ADDENDUM NO. 1 (BULLETIN 8R)

**CLOUD PRESCHOOL
SITE IMPROVEMENTS
GLENDALE UNIFIED SCHOOL DISTRICT
BID NO. 198-19/20**

BULLETIN NO. 8R
 DATE: 4/21/2020
 DSA NO. 03-119149
 THIS REVISES IN PART
 SHEET: AS-1
 SHEET: B-008R-01

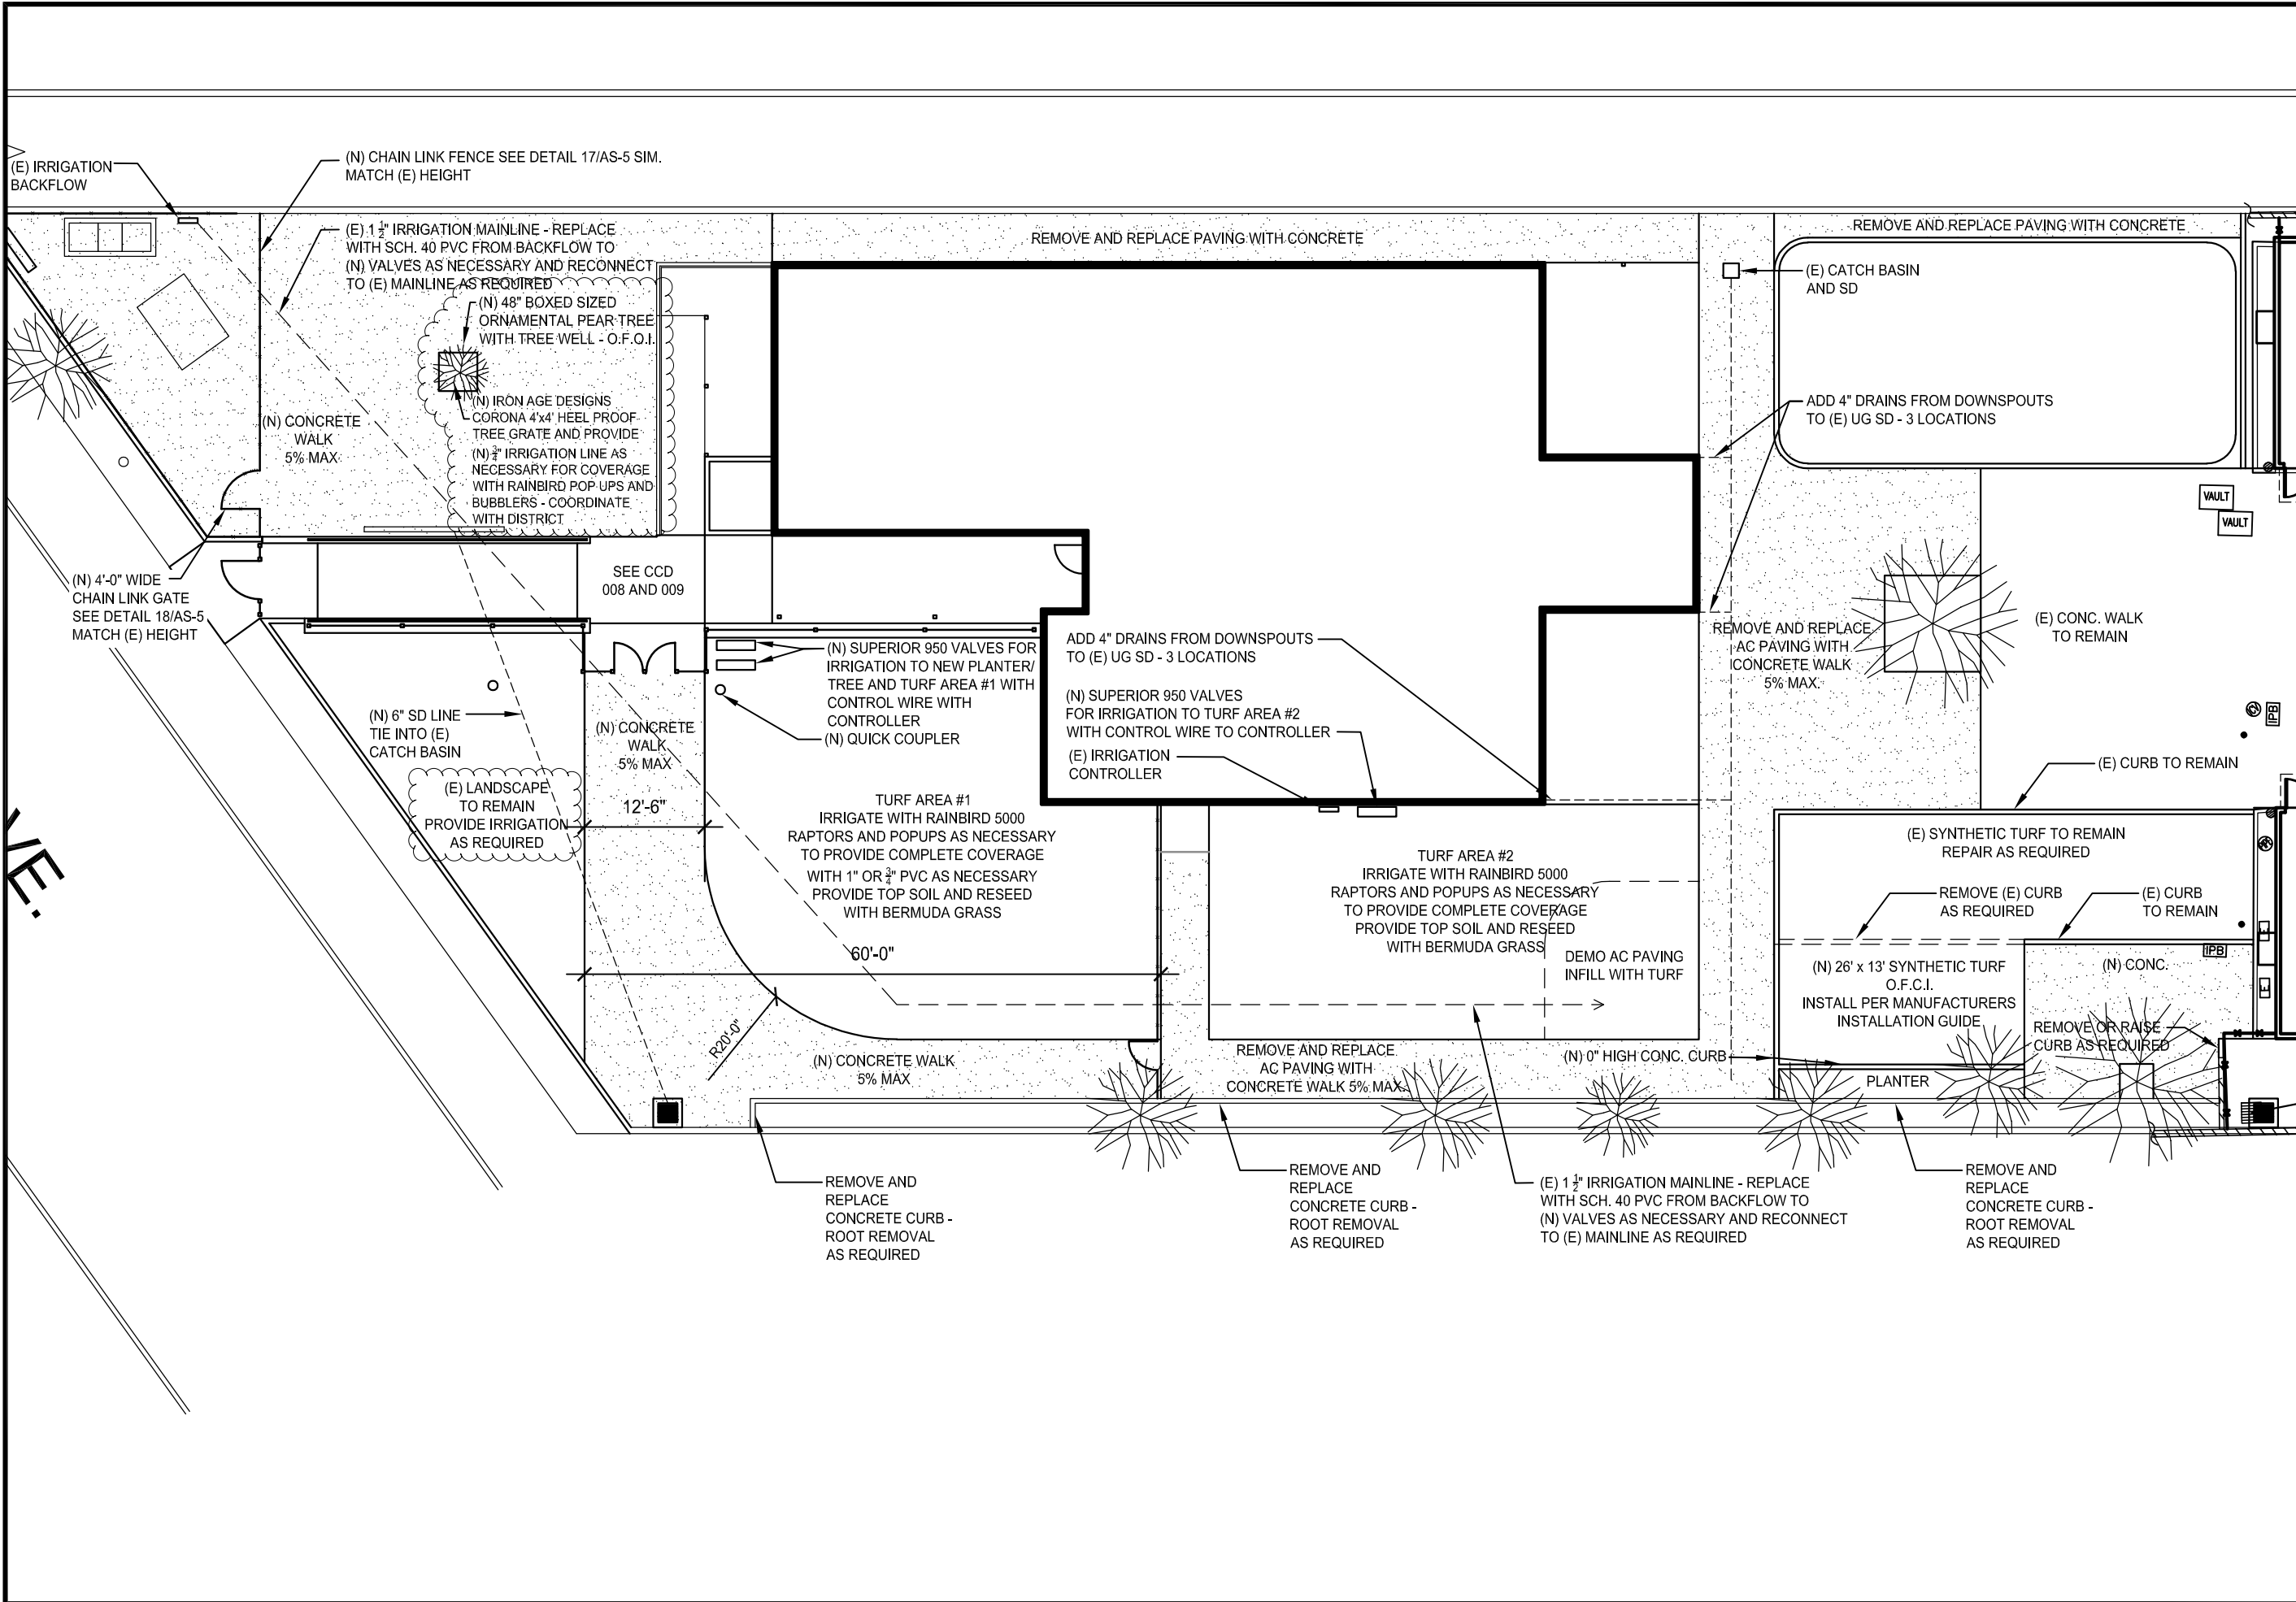
1. BULLETIN 8R
 - a. Replace sheet B-008-01 and Detail 11/A7-1 with attached sheet B-008R-01 and Detail 11/A7-1, issued with this Addendum.

1. Reference Sheet B-008-01
There was no finished called out at portion of the front yard as indicated. Is this turf or concrete?
Response – This area is existing landing that is to remain. Irrigation to this area shall be provided as required. See attached sheet B-008R-01.
